Access Compliance Report

Public Rights-of-Way

Intersection ID: 10033982	Main Street: PARK_RD	Cross Street: N/A	Location: NE
ADA ID: 5B67365306EA	Ramp Type: BlendTrans2	Initial Pass/Fail: Fail	Overall Compliance: No
		Severity Score: 8.75

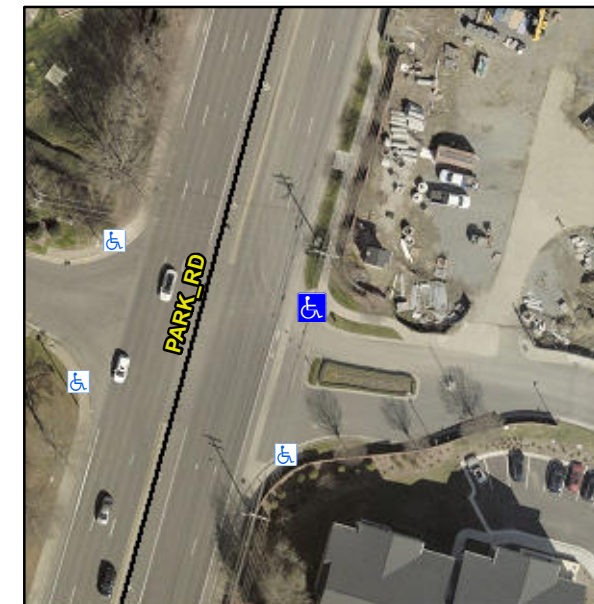
Not Found, R304.5.1

Remove & Replace Curb Ramp With Two New Directional Ramps or Equivalent.
